) MM ARE IN MILLIMETERS	==			
UNLESS OTHERWISE SF TOLERANCES NON-ACCU		drawn D. WALDRON	DATE 12/22/92	<b>EXECUTION IC.</b> INC.		
TOL. ON INCHES	ММ	снескед ВЕ	1/20/93	HOPEWELL, NJ VENTURA, CA USA		
.XX ± .02	±	FNG	1/20/93			
.XXX ± .010	<u>+</u>	JC	1/20/93	WIRING DIAGRAM 115V		
ANGULAR ± 1/2° MFG.		MFG. ENG.		TRANSFORMER W/50/60 SWITCH		
MATERIAL				CODE IDENT. NO. SIZE DWG. NO. REV		
LIMITO		APPROVED		06223 A WD-138 B		
UNITS KAC3P25T-2 KAC	4P28-8	G.ROSENKRANS	1/20/93	SCALE 1=1 CAD. REF. WD000026 SHEET 1 0F 1

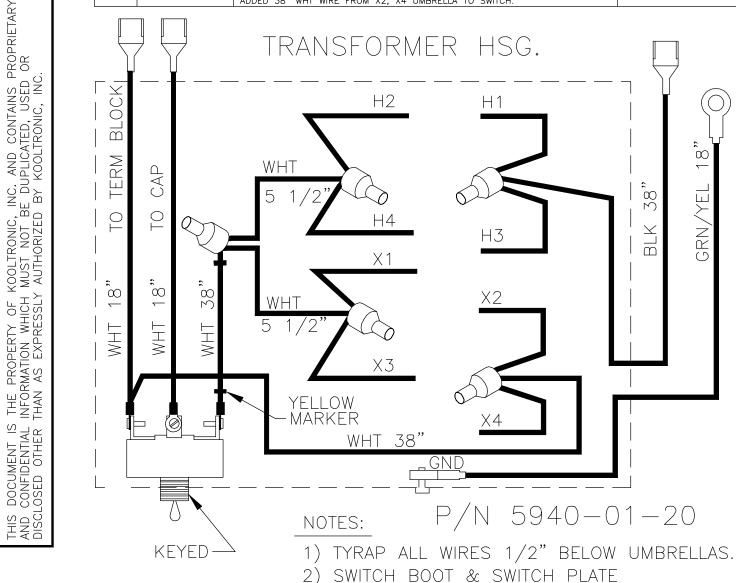
REVISIONS							
SYM	NOTICE	DATE	APPROVED				
-	EC 93/01	12/22/92	D W				
Α	EC 93/235	4" WHT WIRES WERE 4" BLK WIRES	10/15/93	RDG			
В	EC 96/196	CHANGED WIRE LENGTHS (2) WHT TO 18", WAS 23", (1) WHT TO 38", WAS 20" (1) BLK TO 38", WAS 18" ADDED 38" WHT WIRE FROM X2, X4 UMBRELLA TO SWITCH.	7/24/96	JS
